City of Ramsey
Agenda
Environmental Policy Board (EPB)
Monday, January 10, 2022
6:30 pm
Council Chambers, 7550 Sunwood Drive NW

Consider Natural Resources Elements of a Site Plan for a New Retail Building at 7912 Sunwood Drive NW (Project No. 22-101); Case of Northstar Marketplace Station LLC

NORTHSTAR MARKETPLACE
 7912 SUNWOOD DR, RAMSEY, MN

EXISTING CONDITIONS & REMOVALS PLAN

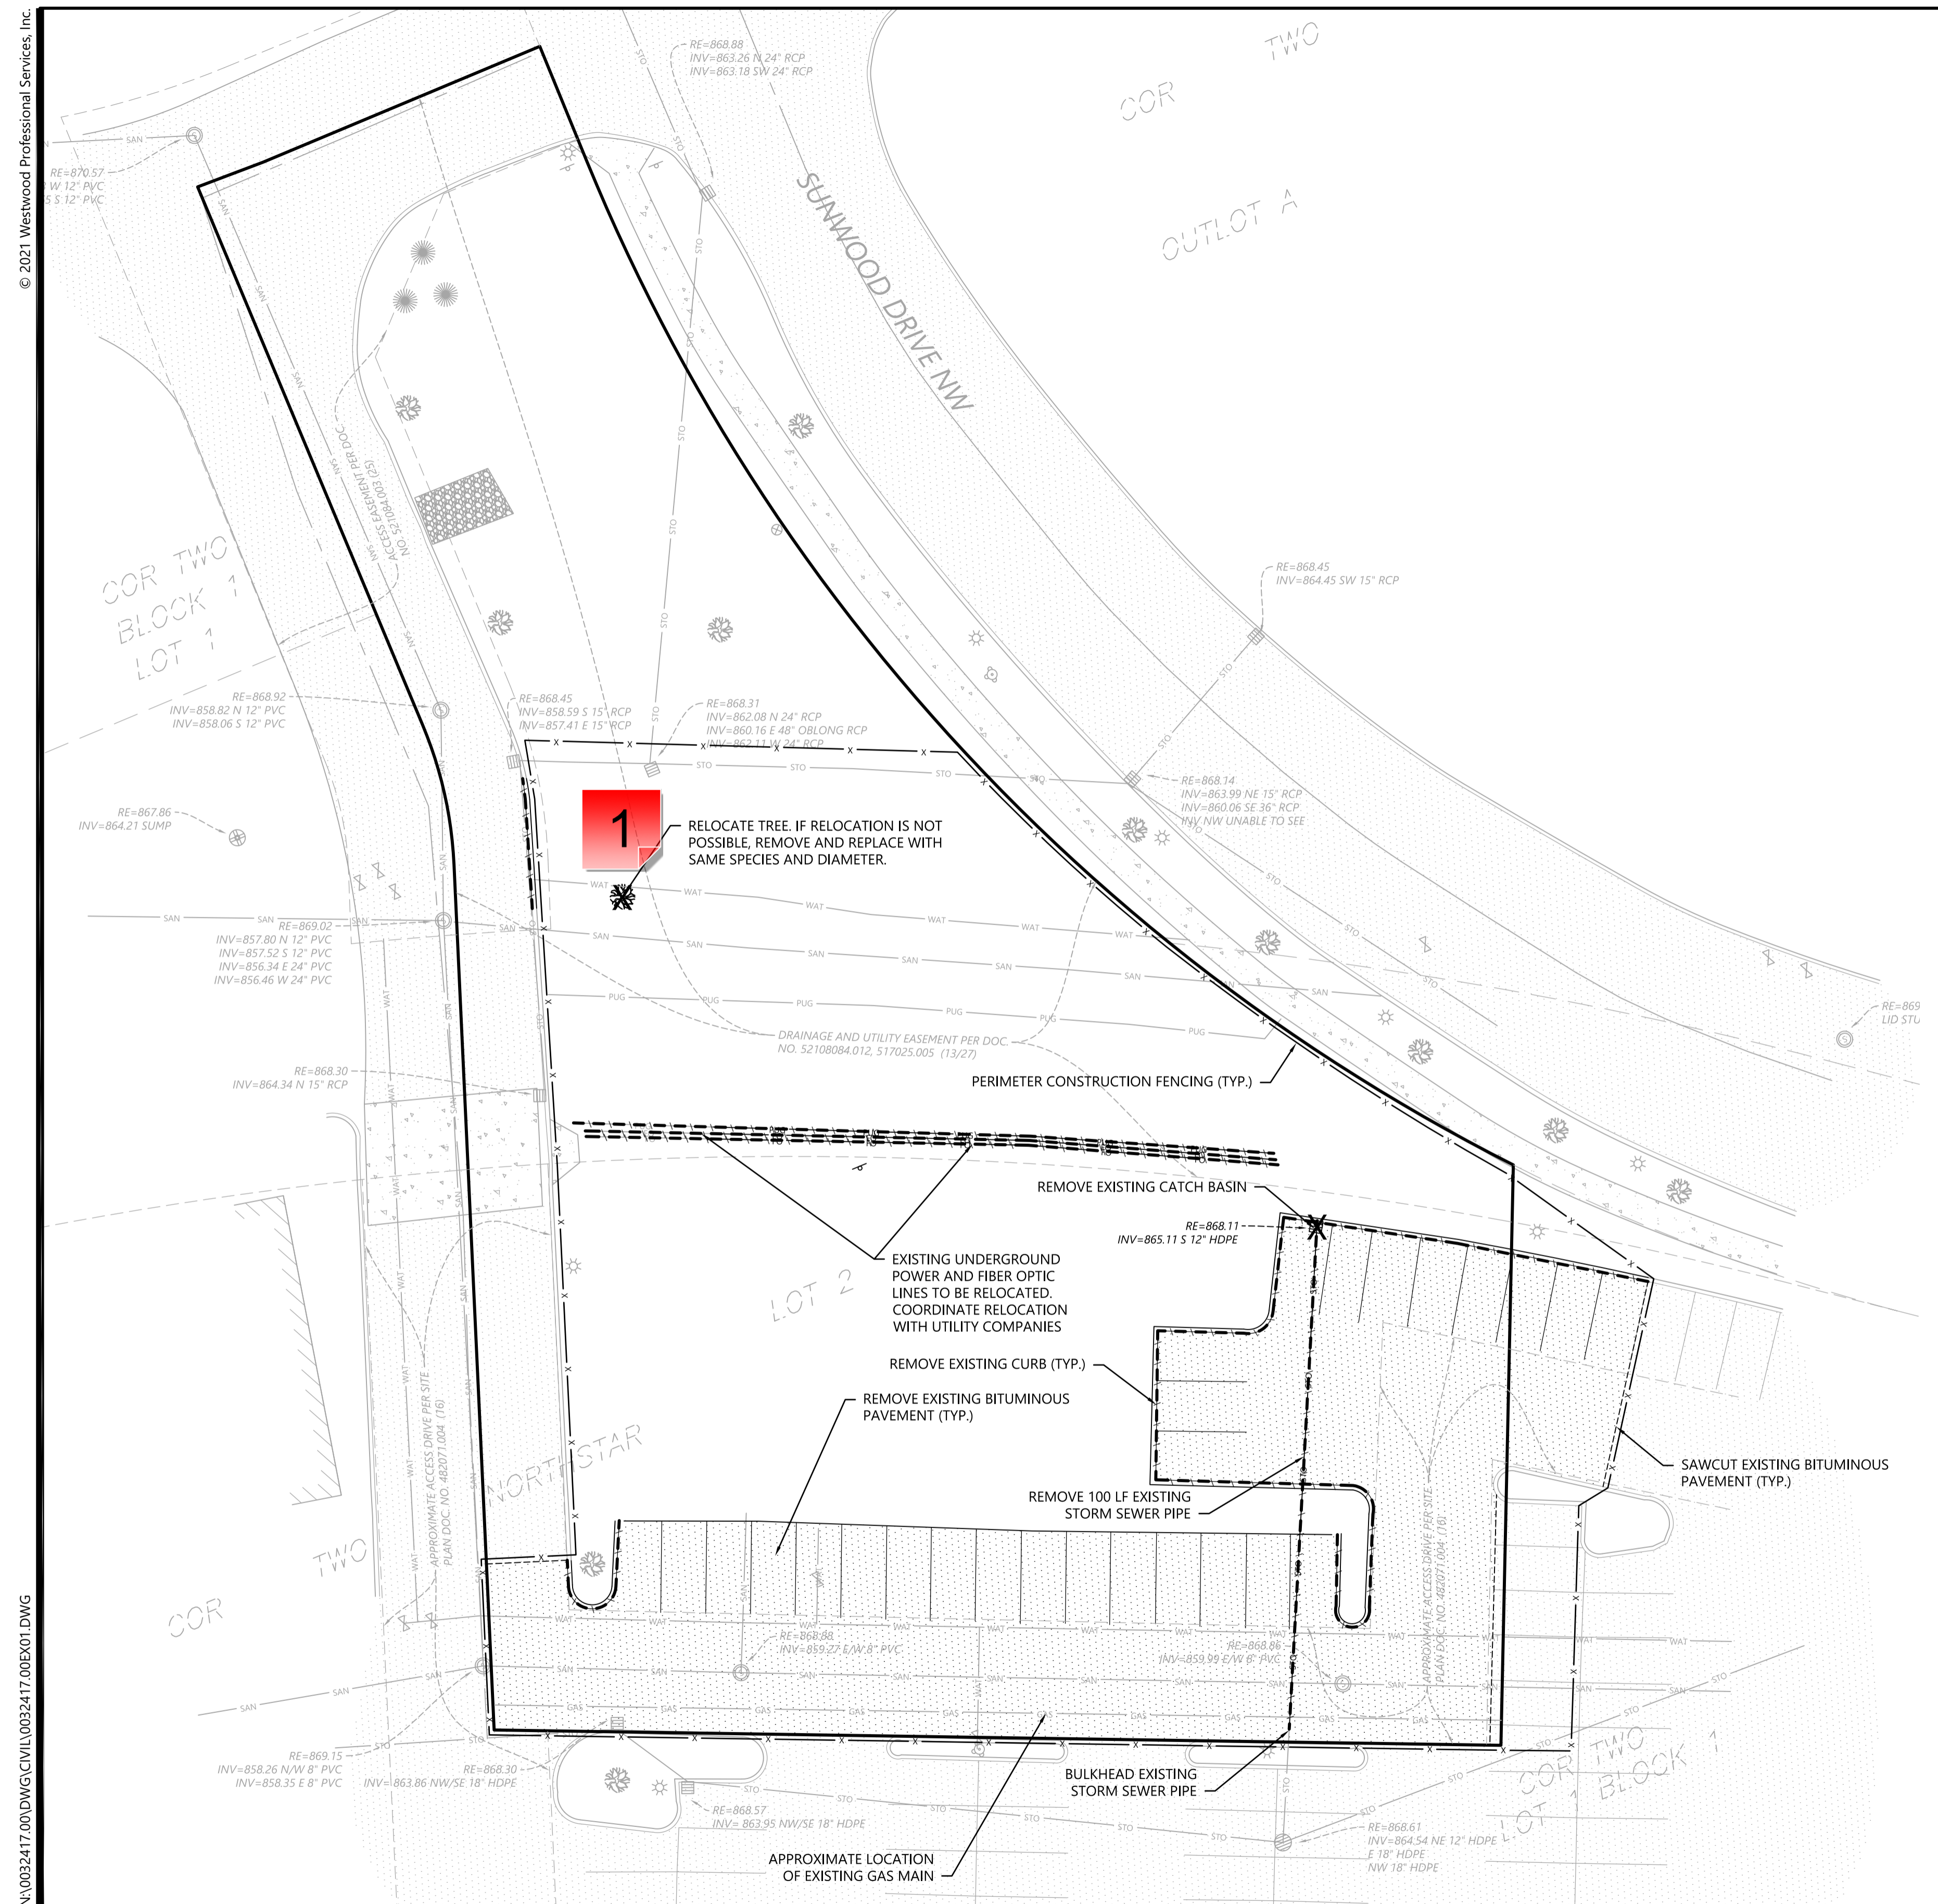
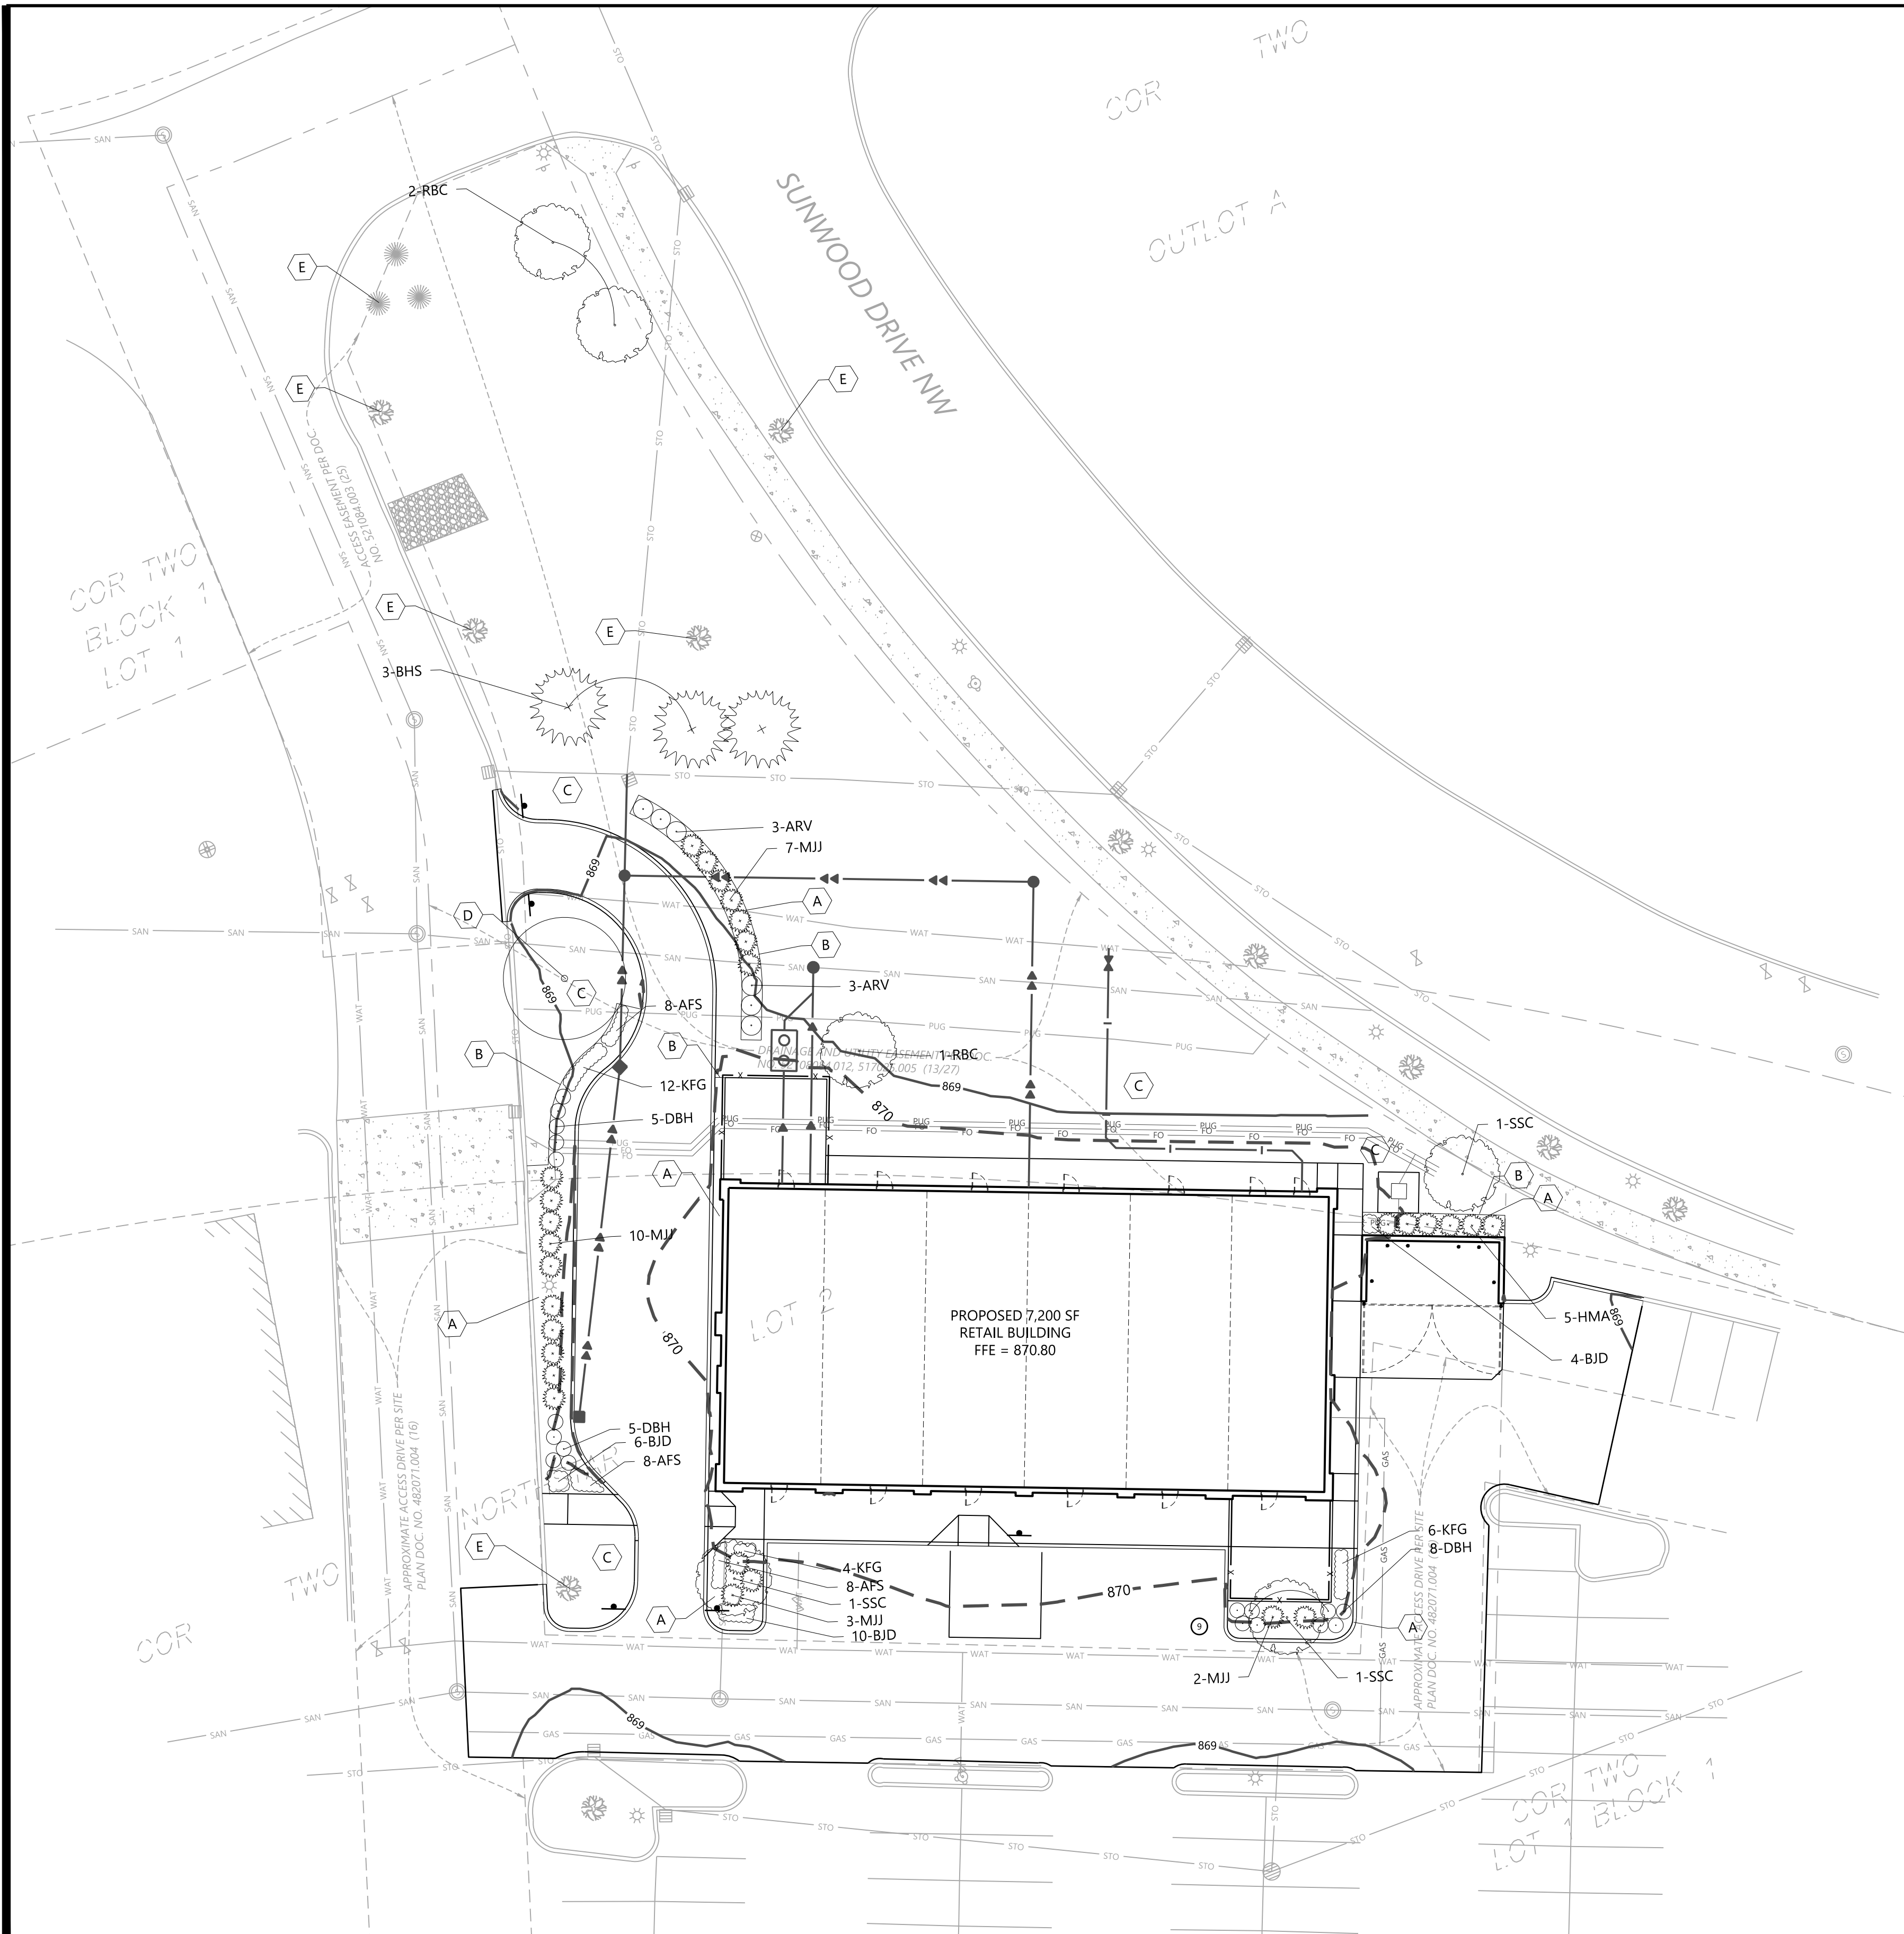
Show where this tree will be relocated on Landscape Plan. If not relocated, show where the replacement tree will be planted on Landscape Plan.

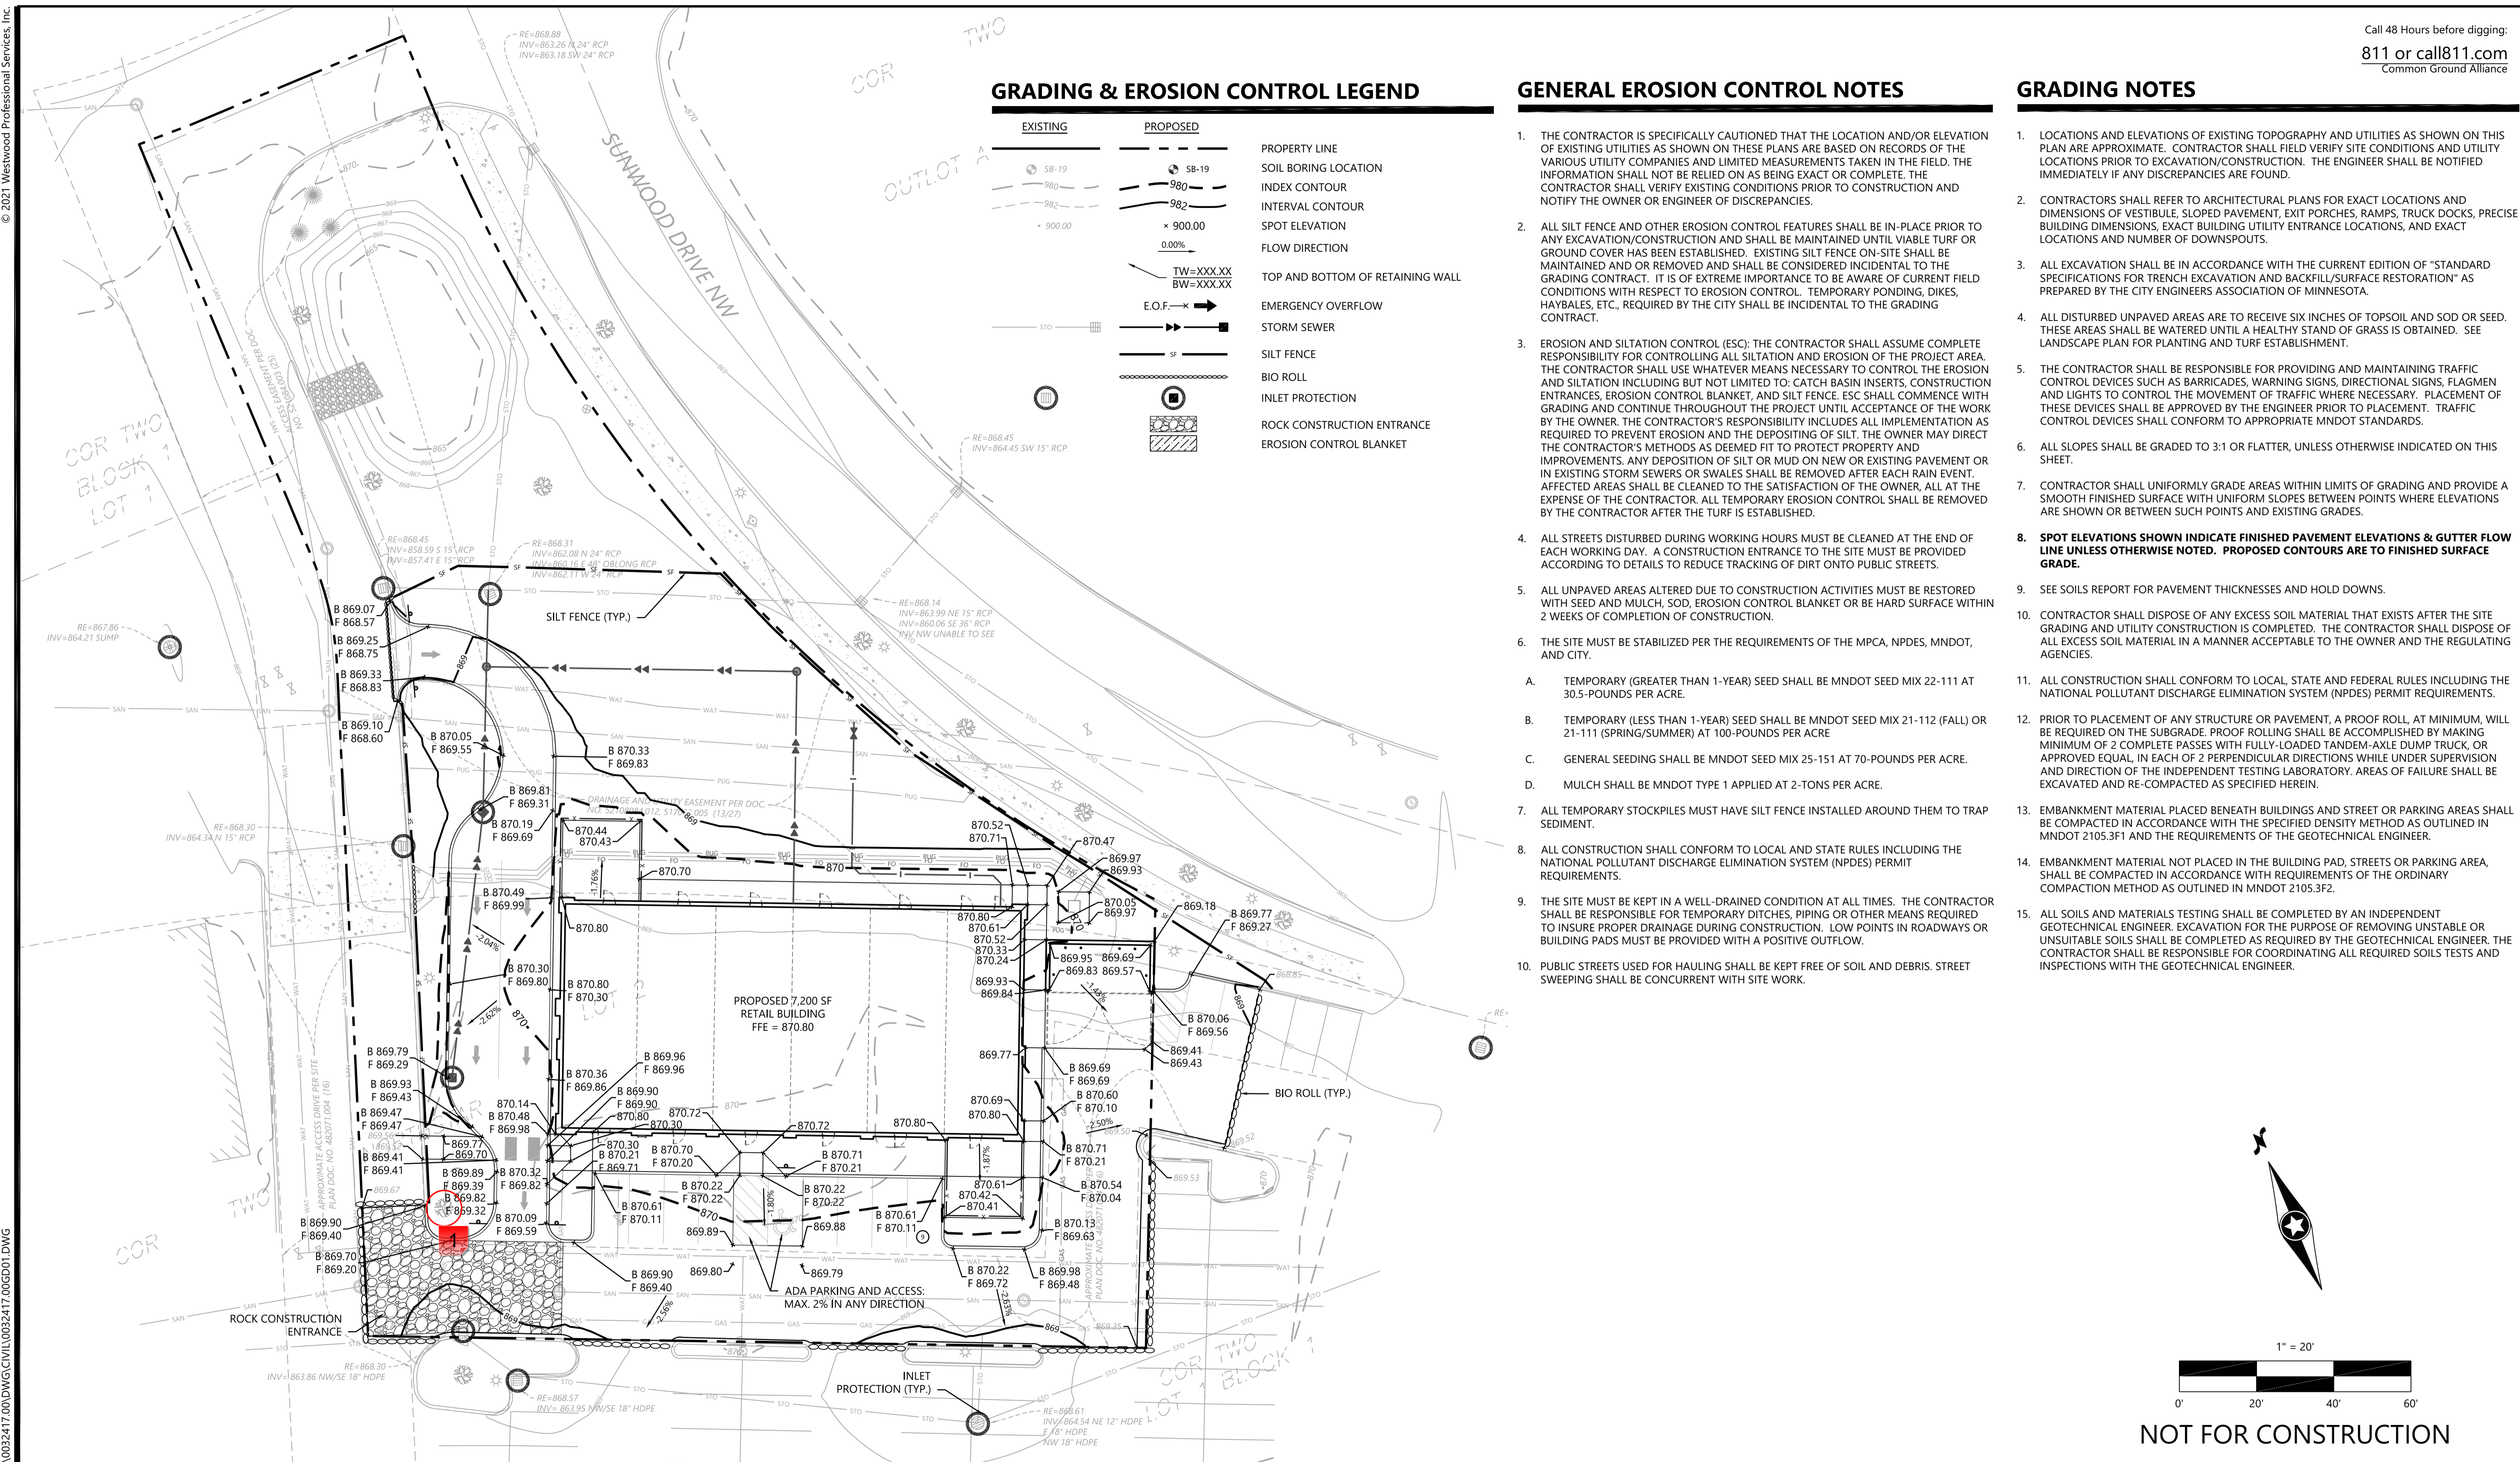
Add tree save fencing around this tree.
